### **PERTINENT WORK PLAN DOCUMENTS**

**WORK PLAN  
FOR INVESTIGATION  
OF  
SOIL AND SEDIMENT CONTAMINATION  
ALONG CYPRESS CREEK  
MEMPHIS, TENNESSEE**

SUBJ: **Joint Conditional Approval** – RFI Workplan for Off-Site Investigation of Soil and Sediment Contamination along Cypress Creek  
Velsicol Chemical Corporation (VCC), Memphis, Tennessee  
EPA ID No. TND 007 024 664

**Velsicol Chemical Corporation Response  
To EPA Comments Dated July 31, 2000  
On the December 29, 1999  
Work Plan for Investigation of Soil and Sediment  
Contamination Along Cypress Creek**

*Revised Figure 2*

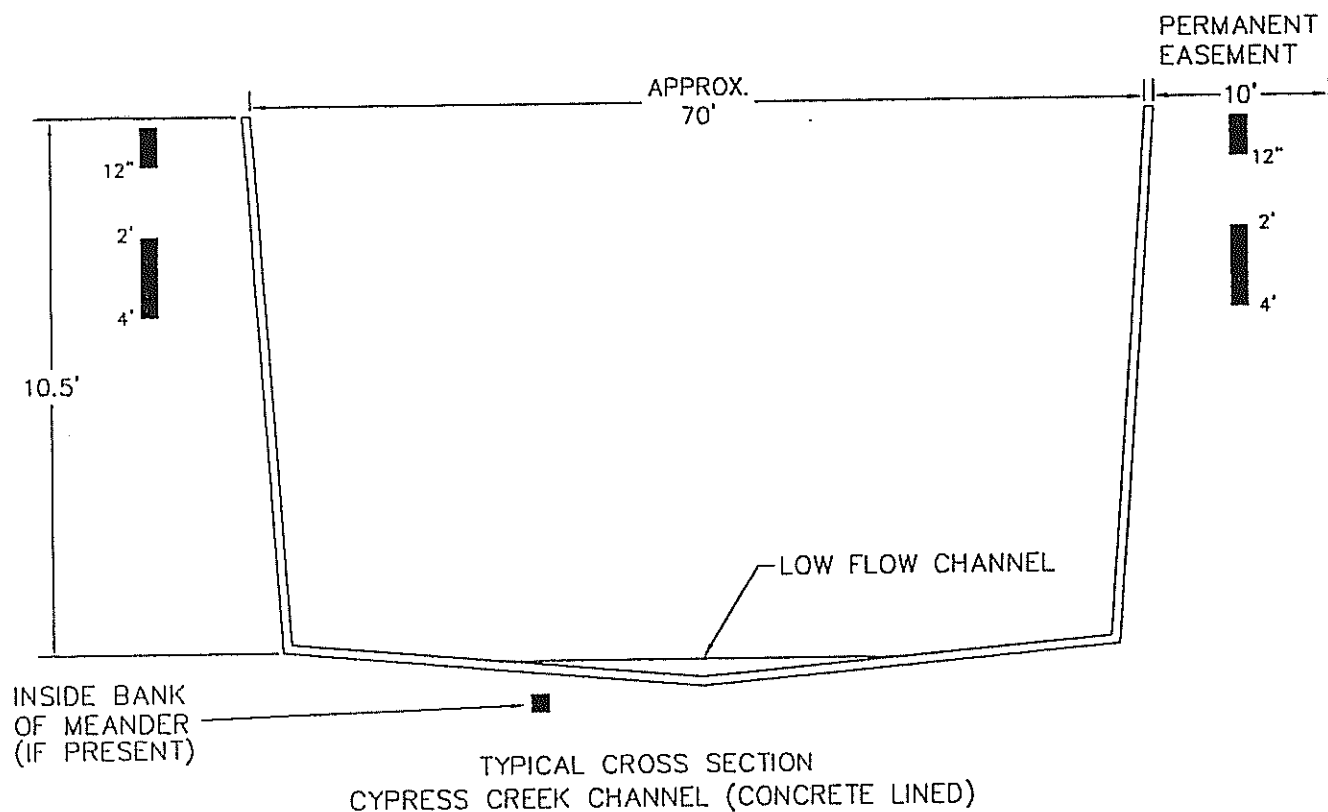
13. Please label "Scott Street" on Figure 2.

14. Increase the scope of work to include adequate data collection to support the DQO's for a Preliminary Risk Assessment. This should include between 12 and 24 additional shallow soil samples at depths of 6-12 inches along banks of Cypress Creek. EPA suggests at least six (6) additional shallow soil sampling sites be proposed between Springdale Street Baptist Church, Cypress Creek Junior High School and University Blvd. Please revise text and Figure 2.

15. Because of potential exposure during stream restoration and pesticide redistribution concerns during sediment dredging in the City of Memphis Surge Basin, EPA also suggests at least four (4) additional transects (stream sediment plus two shallow bank soils samples per transect) in the unlined creek portion between Evergreen Street and the Cypress Creek Surge Basin. Please revise text and Figure 2.

Comment 13. Please label "Scott Street" on Figure 2.

Comment 14. Increase the scope of work to include adequate data collection to support the DQO's for a Preliminary Risk Assessment. This should include between 12 and 24 additional shallow soil samples at depths of 6-12 inches along banks of Cypress Creek. EPA suggests at least six (6) additional shallow soil sampling sites be proposed between Springdale Street Baptist Church, Cypress Creek Junior High School and University Blvd. Please revise text and Figure 2.

- Four (4) surficial sampling locations will be added between Springdale Street Baptist Church, Cypress Creek Junior High School and University Blvd. at the locations noted on the enclosed *Revised Figure 2*. Note that two surficial samples were added to this reach of Cypress Creek by the addition of two surficial samples at transect location T-4 (+4 samples equals a total of + 6 for this reach).

Response: Scott Street has been labeled on *Revised Figure 2*.

Response: See General Response and Proposed Work Plan Approach for a discussion of the expansion of sampling locations/transects and sample collection. *Revised Figures 2 and 4* show the additional sampling locations.

Response: See General Response and Proposed Work Plan Approach for a discussion of the expansion of sampling locations. Significant investigation in this area (both sediments and soil) has been conducted in the past, (see *Revised Figure 2*) such that Velsicol does not believe additional sampling is necessary for the current investigation and Preliminary Risk Assessment. This existing data and its evaluation will be included in the IPRA Report.

FIGURE 5 (REVISION 1)

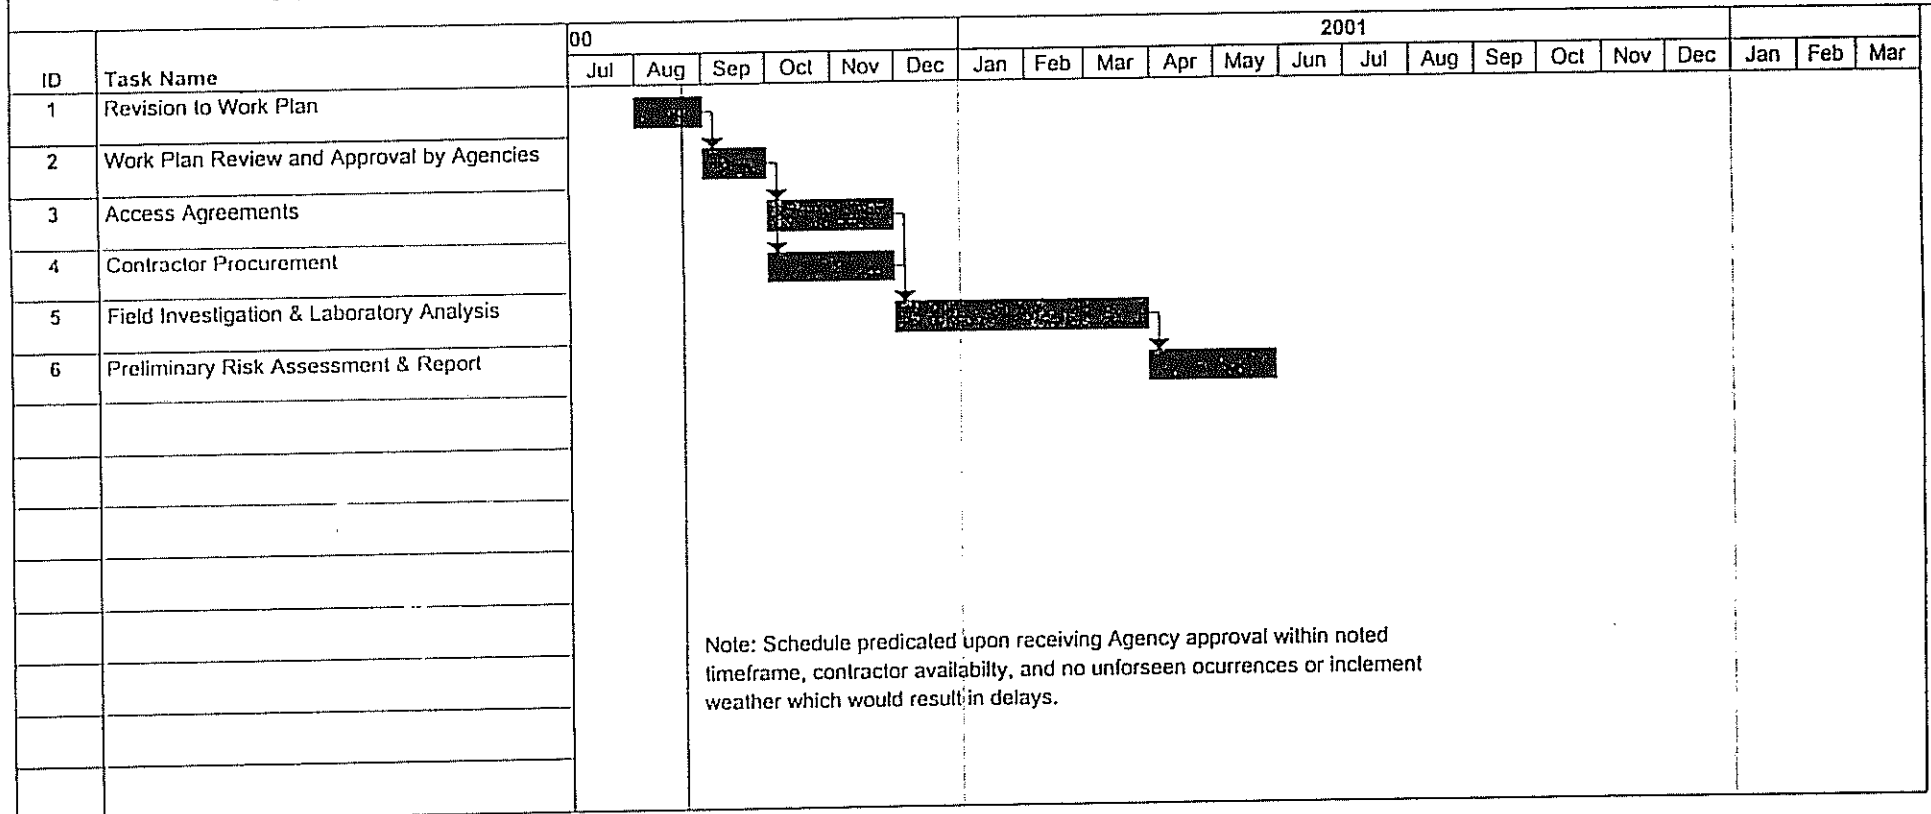
12. Revise the objectives, schedule and Figure 5 of this Cypress Creek Investigation to include data accumulation for a Preliminary Risk Assessment. We recommend that a separate section be created to discuss the basics of the Preliminary Risk Assessment for both the human health and ecological components.

Comment 12. Revise the objectives, schedule and Figure 5 of this Cypress Creek Investigation to include data accumulation for a Preliminary Risk Assessment. We recommend that a separate section be created to discuss the basics of the Preliminary Risk Assessment for both the human health and ecological components.

Response: The revised Work Plan will be implemented following Agency approval of this response and according to the revised schedule, as shown on the enclosed *Revised Figure 5*.

*Figure 5*, the project schedule, has been revised to include the Risk Assessment and is attached.
